27 July 2021

## **UNSW HTH - Response to SSDA Queries**

Foundation Plan – Illustrating proximity of structure to the light rail

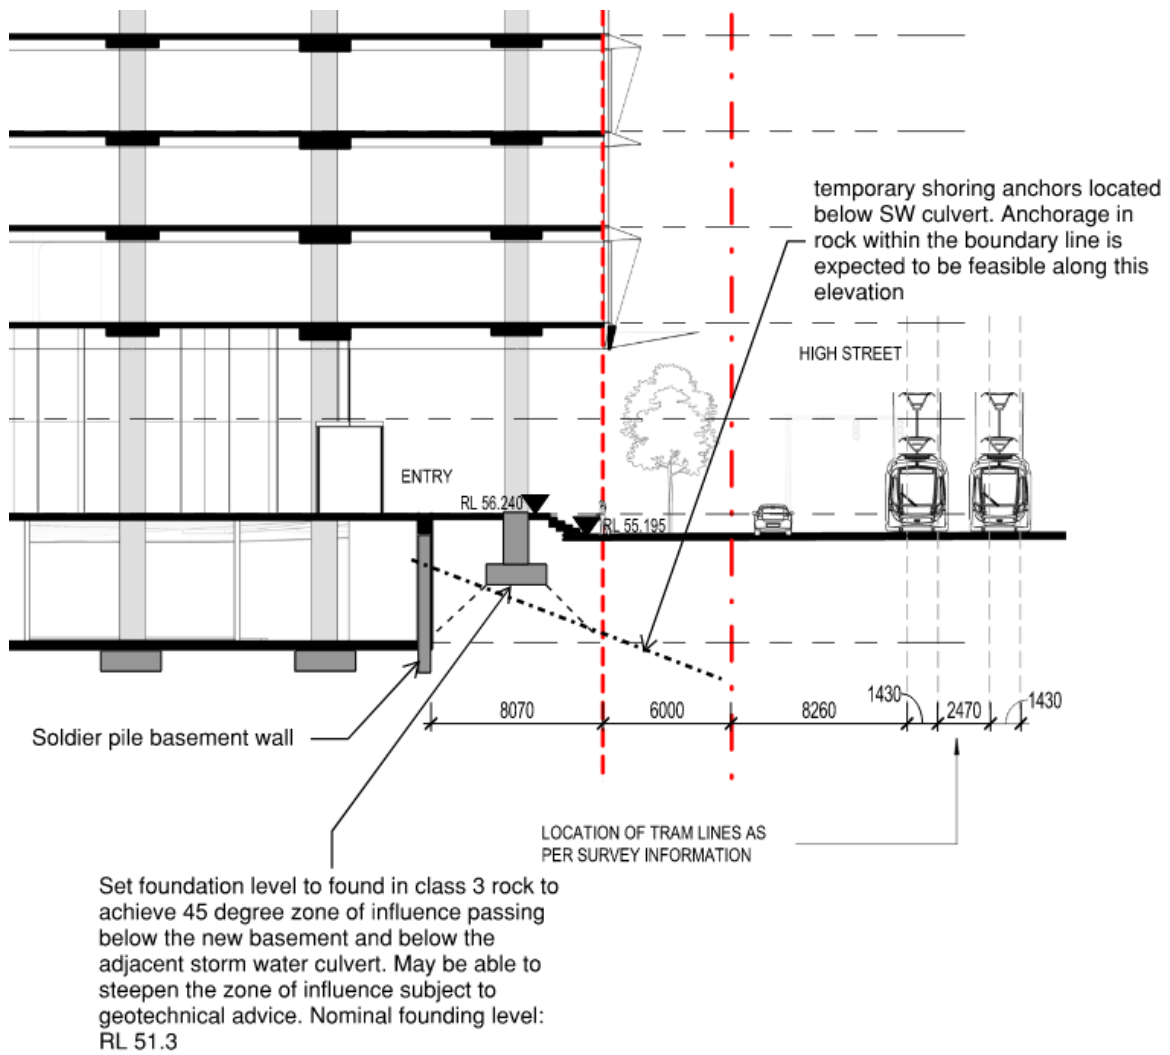
The appended sketches show the dimensioned setting out of the proposed building structure, sub-structure and temporary shoring anchors relative to the existing light rail. We can confirm that the proposed HTH basement shoring and foundations will impose negligible influence on the existing light rail.
